**Subject: Section 8 of the Red Hill Administrative Order on Consent ("AOC")
Statement of Work ("SOW") Approval of Section 8.3 and Requirement to
Complete Additional Work**

Subject: Honolulu Board of Water Supply (BWS) Comments on ABS Consulting (ABS) Report "Quantitative Risk and Vulnerability Assessment Phase 1 (Internal Events without Fire and Flooding) dated November 12, 2018" and "Navy's Risk and Vulnerability Assessment Summary" and Cover Letter dated May 29, 2019 as per Red Hill Bulk Fuel Storage Facility (RHBFSF) Administrative Order on Consent (AOC) Statement of Work (SOW) Section 8

Source: NAVFAC, 2019c – First Quarter 2019 – Quarterly Groundwater Monitoring Report, Red Hill Bulk Fuel Storage Facility, Joint Base Pearl Harbor-Hickam, Oahu, Hawaii. May.

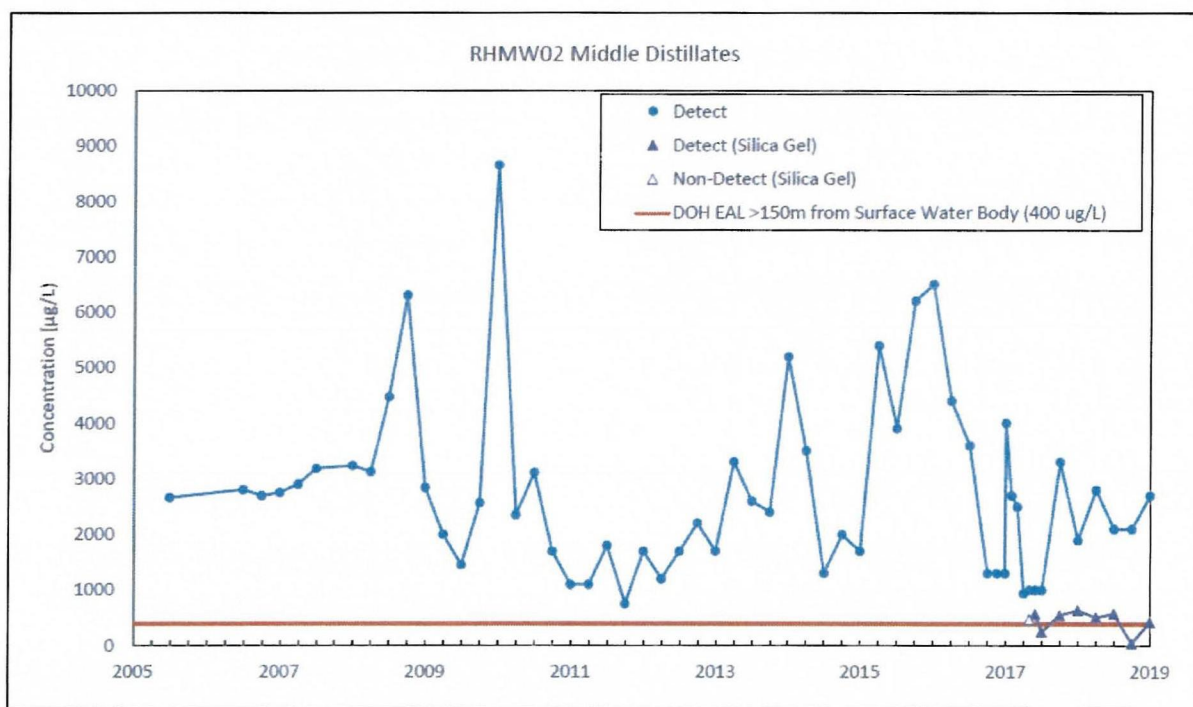
Groundwater data indicates that fuel continues to migrate to groundwater. As shown in the graph below, fuel constituents have been identified in groundwater samples collected from monitoring well RHMW02 since 2005. RHMW02 is the monitoring well located in the approximate center of the lower access tunnel and midpoint of the RHBFSF tank farm.
